SUBJECT: TRANSMITTAL OF TRIP REPORT, MADRID AND CORDOBA,
SPAIN MAY 1 - 15, 1989

ENCLOSURE - TRIP REPORT,
MADRID AND CORDOBA SPAIN

Madrid and Cordoba, Spain
Licensing Consultation with CSN on El Cabril
Low-Level Radioactive Waste Disposal Facility
May 1 - 15, 1989

Cubetitos (Best Available Diagram)

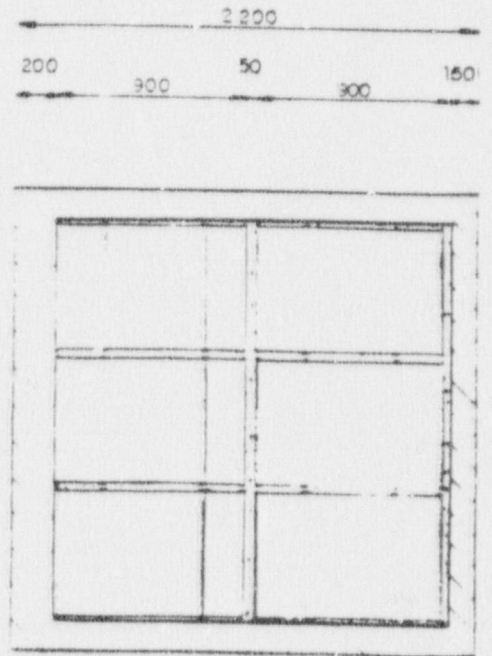
IMPORTANCE OF DEFINING AND RESOLVING ISSUES
MAGNITUDE
FREQUENCY
EFFECT
SEISMOTECTONIC ELEMENTS OF IMPORTANCE
GUADILQUIVIR FAULT (ATTENUATION)
"FAR FIELD" SEISMIC ACTIVITY (AZORES SUTURE)
MICROSEISMIC ACTIVITY (LOCALIZED VS. RANDOM)
ISSUE IS EFFECT
COVER
CUBETITOS
PATHWAYS

BASIS FOR INVENTORY ESTIMATES NOT CLEAR
LEACH CHARACTERISTICS SOLIDLY BASED
MULTIPLICATION OF LEACH ESTIMATES BY 0.01 NOT EXPLAINED
DRUM DURABILITY NOT CONSIDERED
BEHAVIOIR OF CUBETITOS AND FINAL COVER NOT CLEAR

Detail of Infiltration Limiting Cover Design

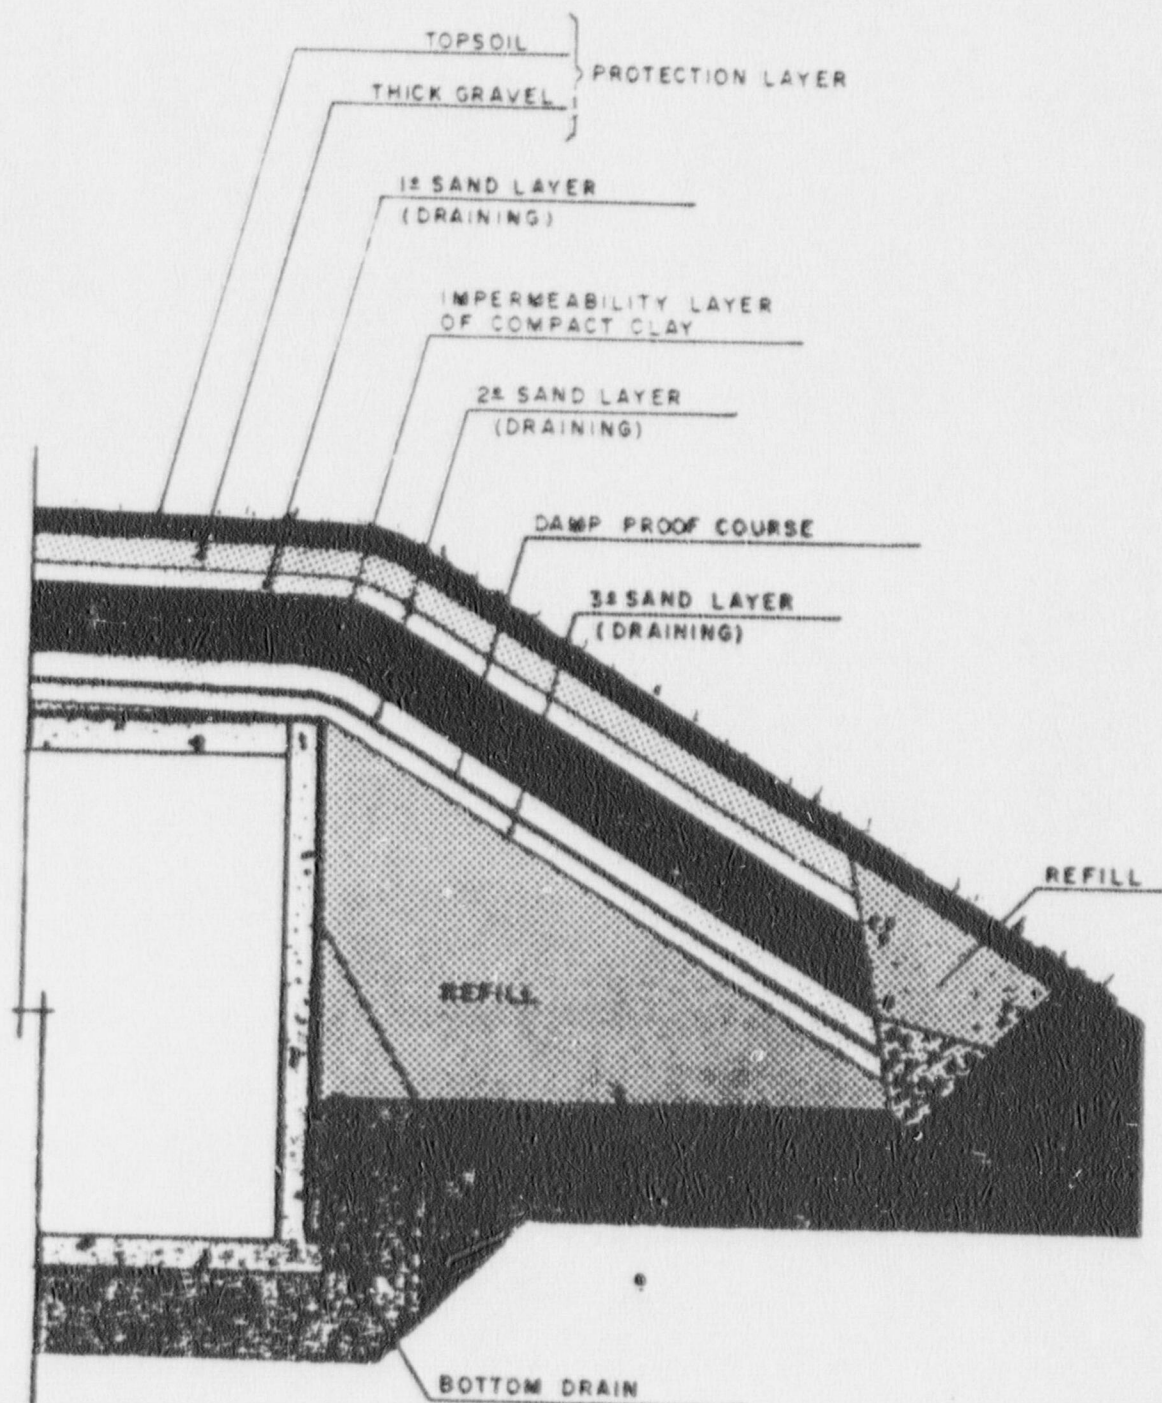
The rest of the design is not unusual, but they plan on long term surveillance and on leachate collection and treatment. The idea of stabilizing the slopes of the final covers with vegetation seems somewhat optimistic given the arid climate and the sparse native vegetation, particularly where the ground has been disturbed. Otherwise, the design and proposed operation is similar to designs that have been proposed by developers in the United States, particularly developers trying to meet stringent State regulations.

BASIS FOR PERFORMANCE ESTIMATES NOT GIVEN
CONSTRUCTABILITY
STABILIZATION AGAINST EROSION
STABILITY AGAINST EARTHQUAKES
REPAIRABILITY
